Florida Department of Environmental Protection

Re: Request for an Amendment for an Extension of Time to Complete Tests for Pollutant Emissions While Firing a Blend of Petroleum Coke and Coal in Tampa Electric Company's (TEC) Big Bend Unit #4, Site Certification No. PA 79-12; and, Amendment to PSD-FL-040(Aa)

Re: Tampa Electric Company
Big Bend Station, Unit 3 & 4 FGD Integration

BIG BEND UNITS 3 & 4 FGD INTEGRATION PROJECT

DWG. NO. B4277-SK-001

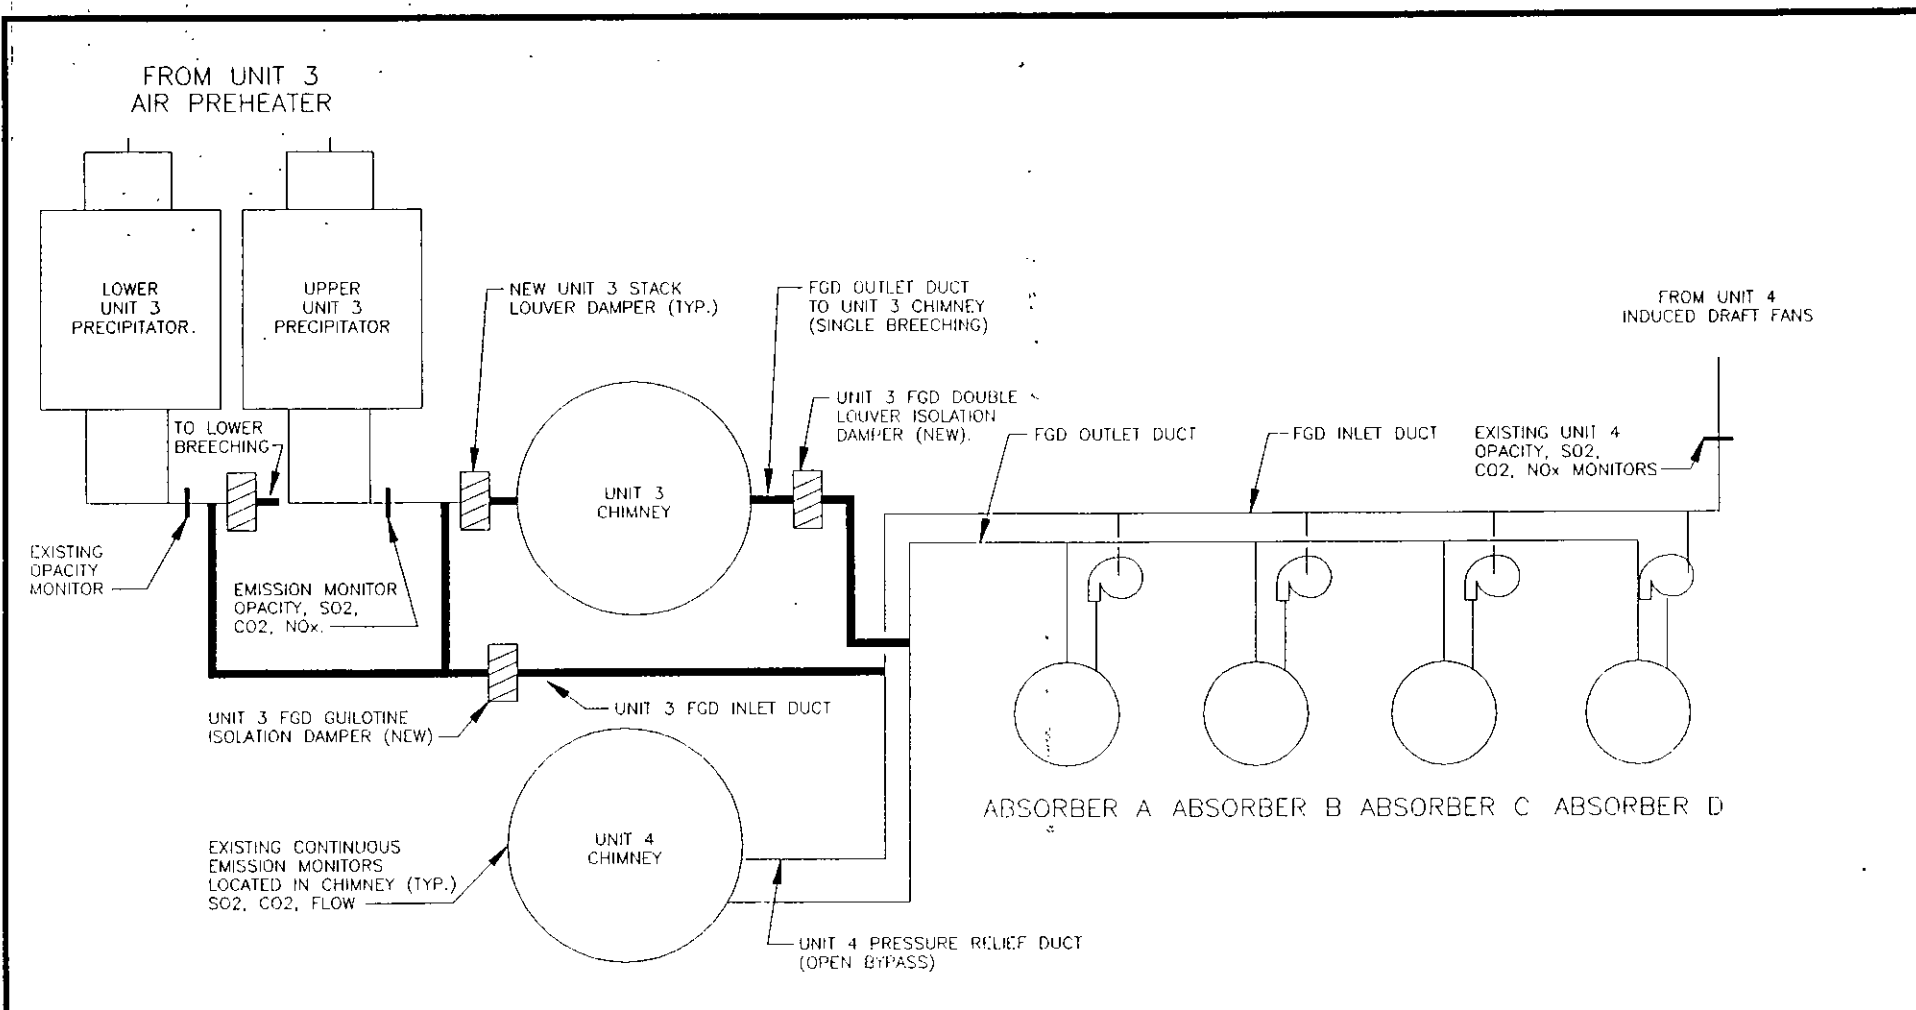
1. According to the project description the NOx analyzer associated with the current Unit 3 continuous emissions monitoring system (CEMS) is being removed and a new dilution gas probe is being installed between the Unit 3 upper ESP exit and the Unit 3 stack. The new probe will be used to collect flue gas samples to be monitored for NOx among other things. Pursuant to 40 CFR 75.20(b) the proposed change in the NOx emissions monitoring system requires recertification of the CEM for Unit 3. Change in the sampling probe location or site for measuring NOx emissions triggers the need for recertification. TEC will need to complete a recertification application and submit to EPA, FDEP, and EPC. The proposed project description did not discuss the possible need for recertification.

2. In the proposed project description TEC acknowledges that during integration the emissions reduction efficiency across the FGD required by NSPS 40 CFR 60 Subpart Da will be met. However, there is no indication that the emissions limit for

Unit 4 at the stack outlet will have to be met during integration for both the Unit 3 and 4 stacks. The PSD-FL-040 permit on Unit 4 has emission limits of 0.82 lb/MMBTU SO₂ (30 day rolling average), 0.6 lb/MMBTU NO_x (30 day rolling average), 0.03 lb/MMBTU PM (continuous limit), 0.014 lb/MMBTU CO (continuous limit) and 20% opacity. During integration since emissions from Unit 3 and 4 will be mixed the more restrictive emissions limitation will have to be met by both emission points (Stacks 3 and 4). It is also our understanding from discussions with EPA during the integration operating mode the Unit 3 stack emissions will be subject to NSPS 40 CFR 60 Subpart Da requirements. The more restrictive emission limits applicable during integration need to be reflected in the permit for Unit 3.

4. A more detailed description of the operation of the isolation dampers is required. How are they monitored? Are they opened and closed manually or electronically? How will the regulatory agencies be able to verify the operating status when conducting on-site inspections? A more detailed description of the operation is required to provide reasonable assurance that Unit 4 emissions are not vented through the Unit 3 stack during the nonintegration operating mode.

5. When Unit 4 was first put into operation there were some initial problems with high opacity which were attributed to some condensible material in the flue gas. Will the proposed removal of the Reheat system have any effect on the opacity from Unit 4? What has changed in the operation which allows them to shutdown the Reheat system?
